STAFF REPORT
COMMUNITY DEVELOPMENT DEPARTMENT

SUBJECT: FP-2021-0052
Gander Creek North Subdivision No. 3

Final plat consisting of 54 buildable lots and 14 common lots on 16.06 acres of land in the R-8 zoning district.

C. Landscape Plan (dated: 07/19/2021)

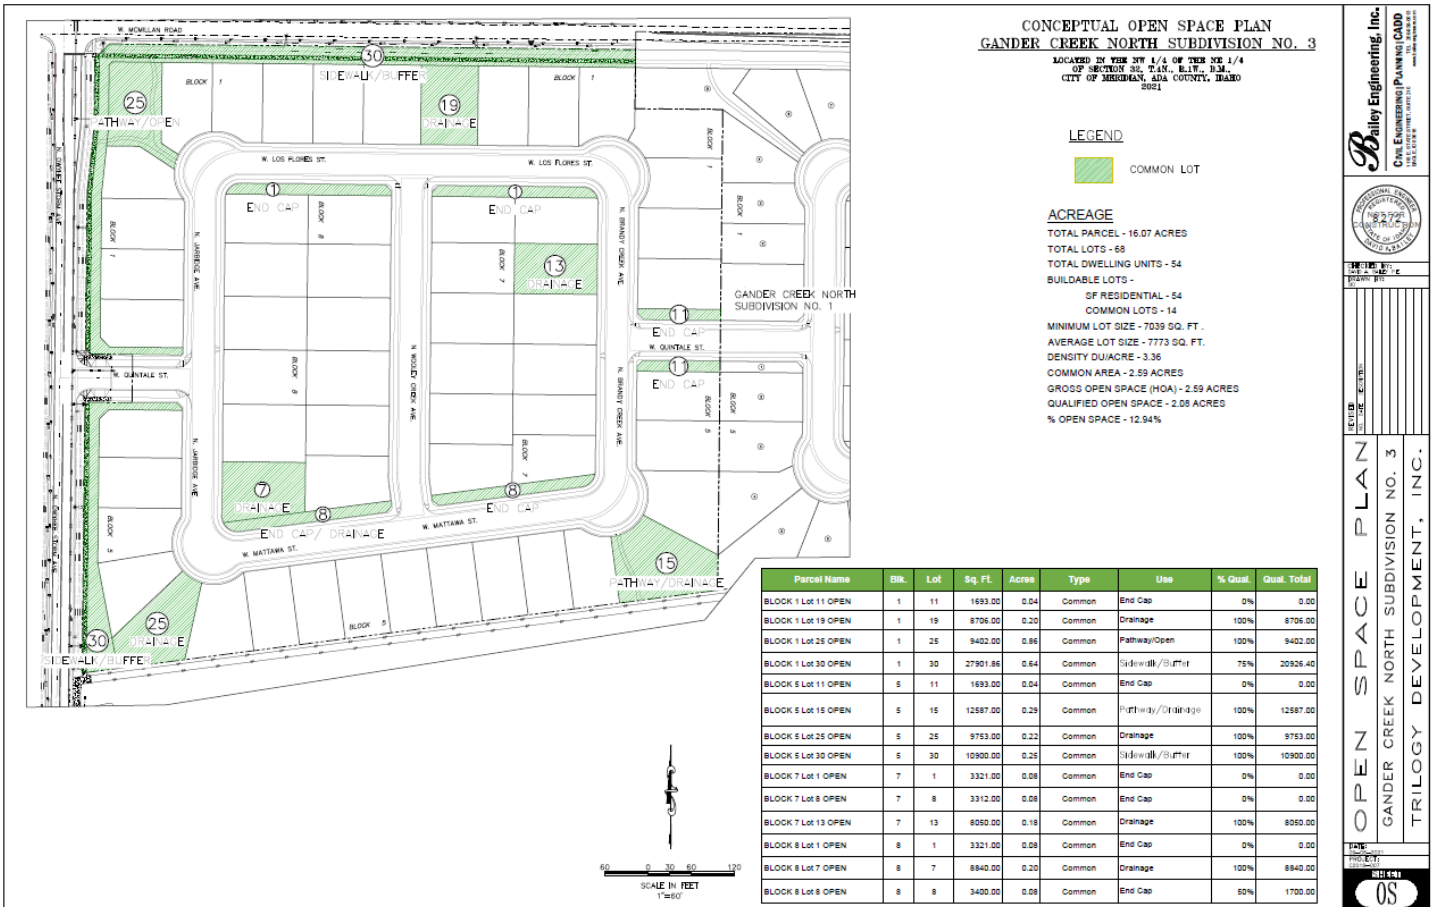
5. The landscape plan prepared by Jensen Belts Associates, dated 09/20/2021, included in Section V.C, shall be revised as follows:
 - a. A minimum of one (1) tree per 100 linear feet of pathway is required adjacent the multi-use pathway along the Five Mile Creek as set forth in UDC 11-3B-12C.2. *If NMID doesn't allow trees within their easement on their property, a common lot should be provided on the subject property to accommodate the landscaping.*

- b. In the Landscape Calculations table, include the required vs. provided number of trees along pathways that demonstrate compliance with UDC 11-3B-12C.2.
